CITY OF ALBUQUERQUE

**Re: Winrock-Mens Warehouse
2100 Louisiana Blvd. NE
30-Day Temporary Certificate of Occupancy- Transportation Development
Transportation Development Final Inspection**
Engineer's/Architect's Stamp dated 02-19-18 (J19D058F)
Certification dated 07-19-18

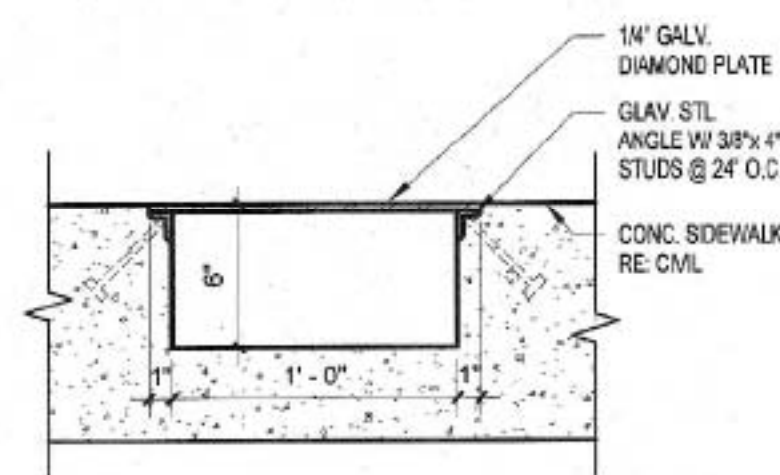
Prior to the issuance of a permanent Certificate of Occupancy, the following items must be addressed:

1. Build Sidewalk Connection.
2. Add "No Parking" marking to ADA access aisle.
